# Staff Report

**To:** Salt Lake City Planning Commission  
**From:** Andy Hulka, Inland Port Principal Planner, andy.hulka@slcgov.com, 801-535-6608  
**Date:** August 9, 2023  
**Re:** PLNPCM2023-00282; Text Amendment Related to Maximum Height in the M-1 District

## Zoning Text Amendment

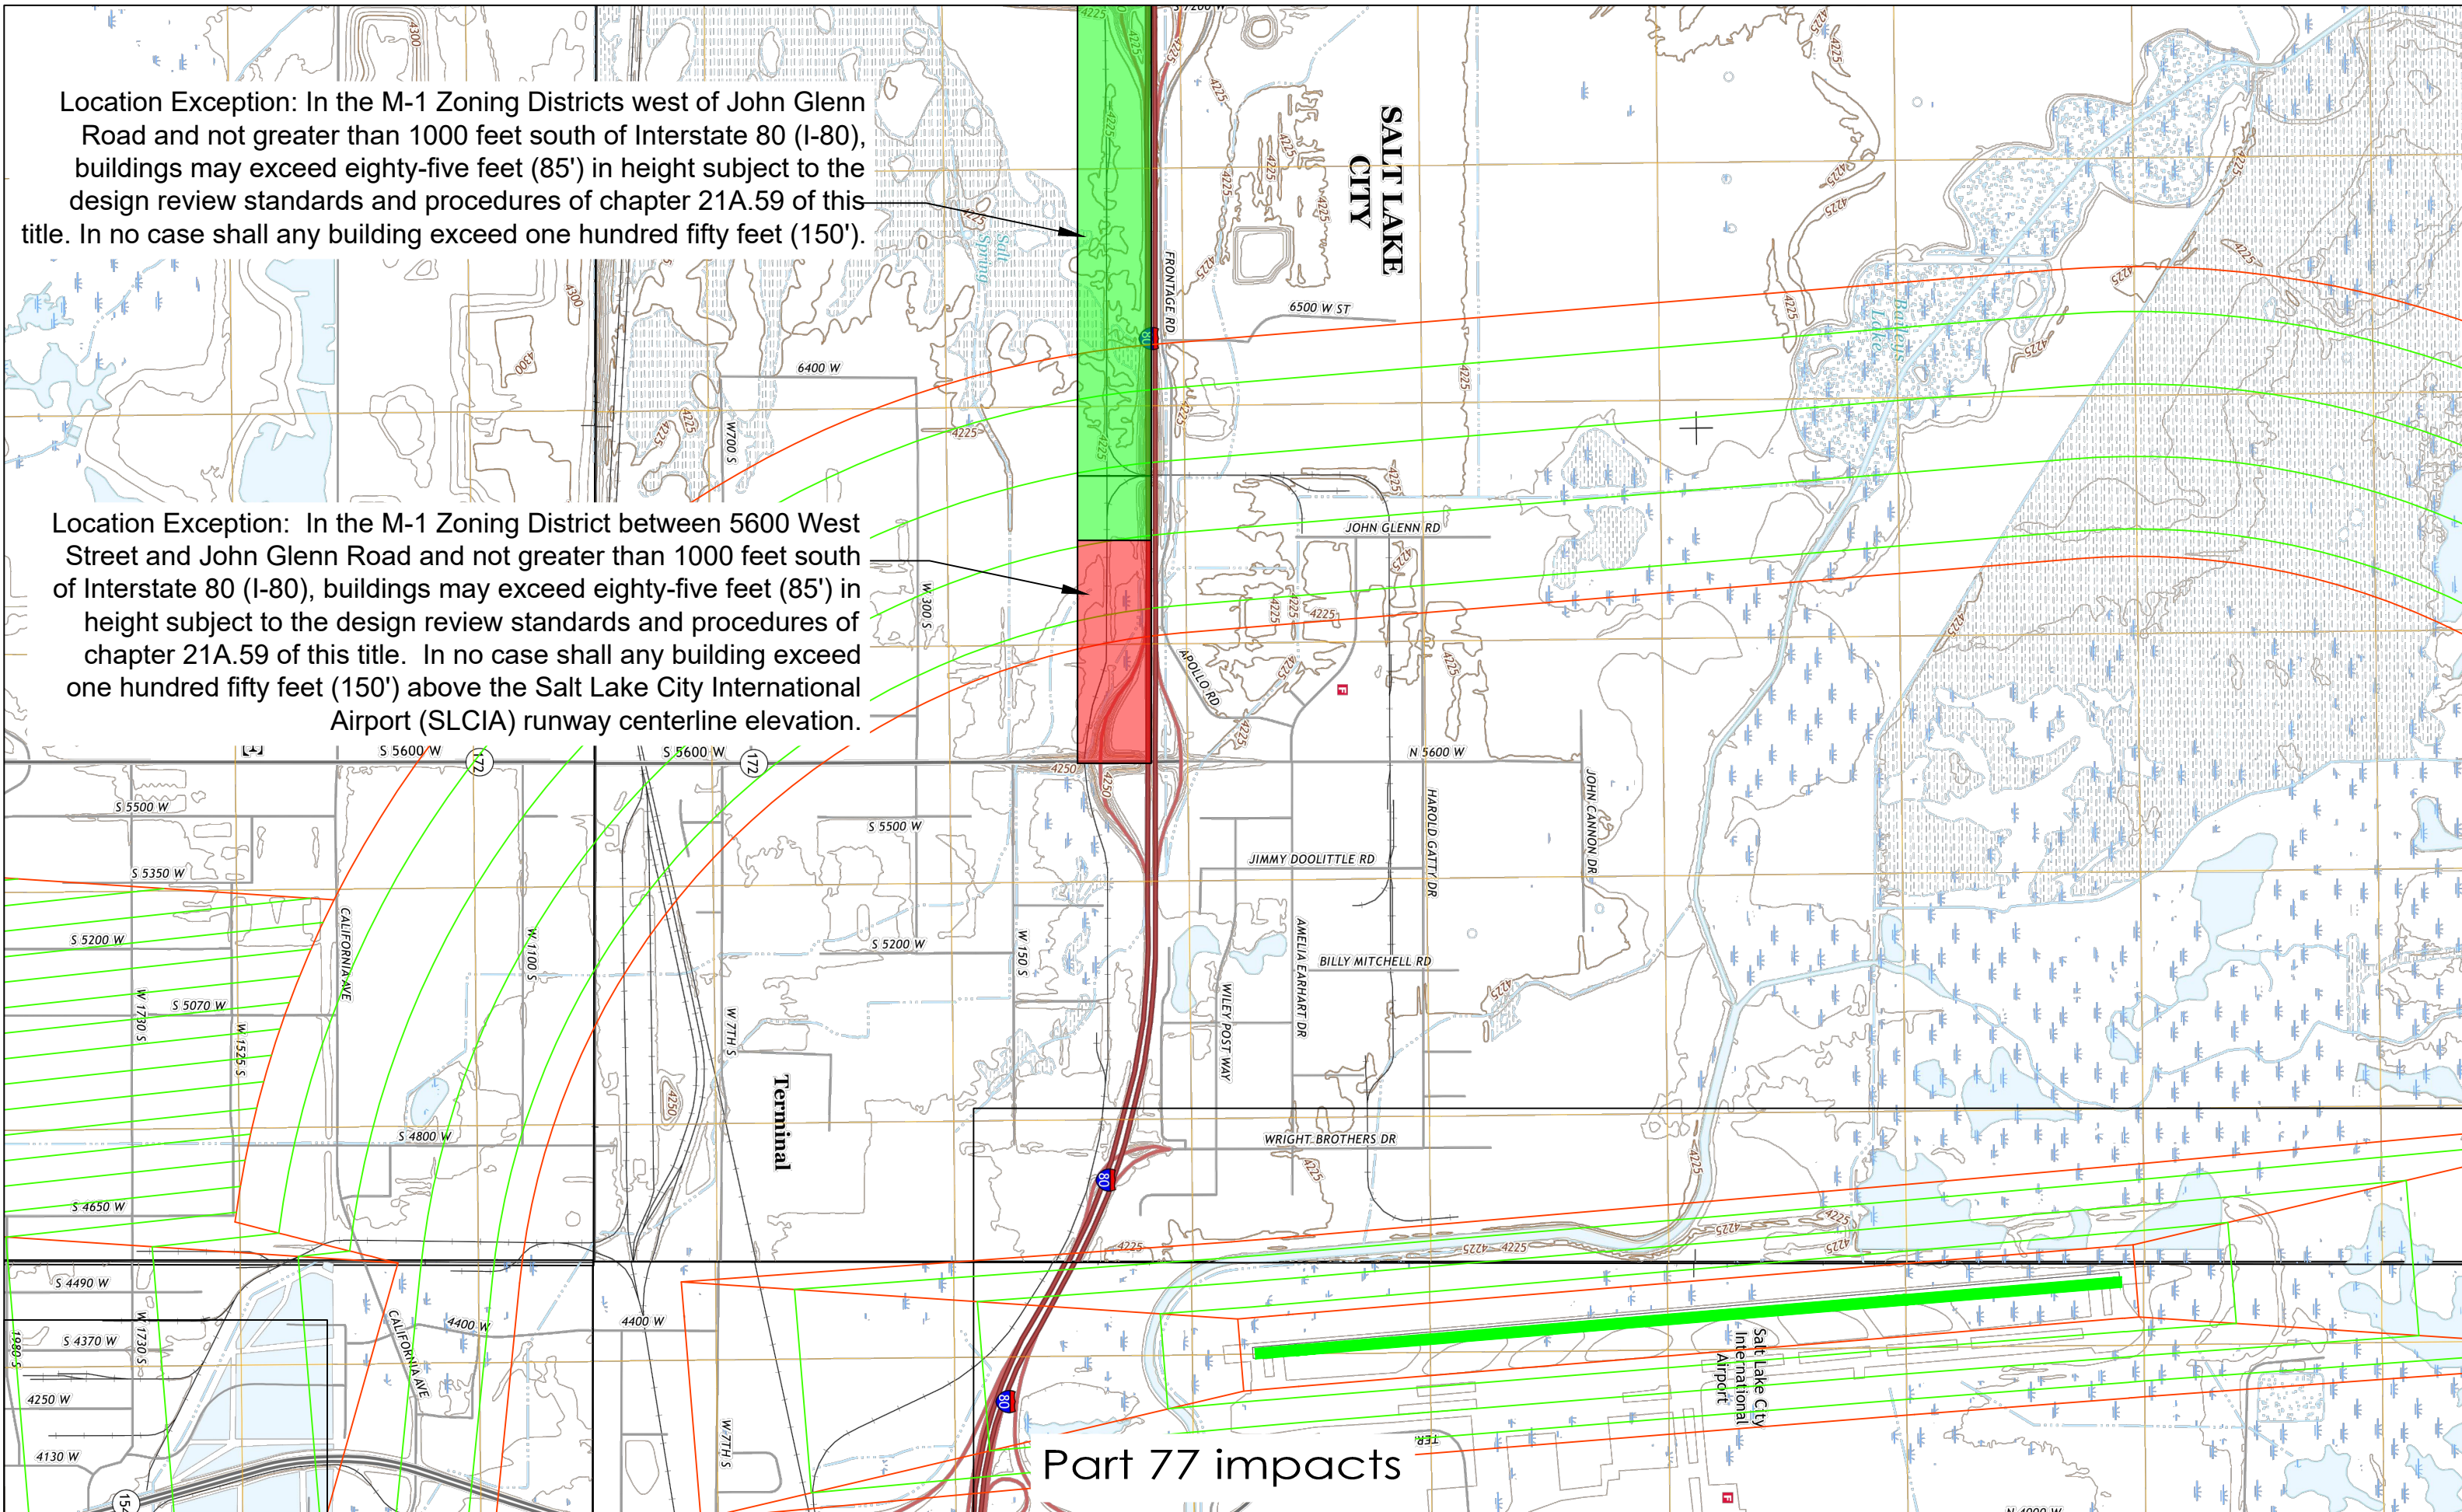
See comments included on attached diagram.

Location Exception: In the M-1 Zoning Districts west of John Glenn Road and not greater than 1000 feet south of Interstate 80 (I-80), buildings may exceed eighty-five feet (85') in height subject to the design review standards and procedures of chapter 21A.59 of this title. In no case shall any building exceed one hundred fifty feet (150').

Location Exception: In the M-1 Zoning District between 5600 West Street and John Glenn Road and not greater than 1000 feet south of Interstate 80 (I-80), buildings may exceed eighty-five feet (85') in height subject to the design review standards and procedures of chapter 21A.59 of this title. In no case shall any building exceed one hundred fifty feet (150') above the Salt Lake City International Airport (SLCIA) runway centerline elevation.

Part 77 impacts
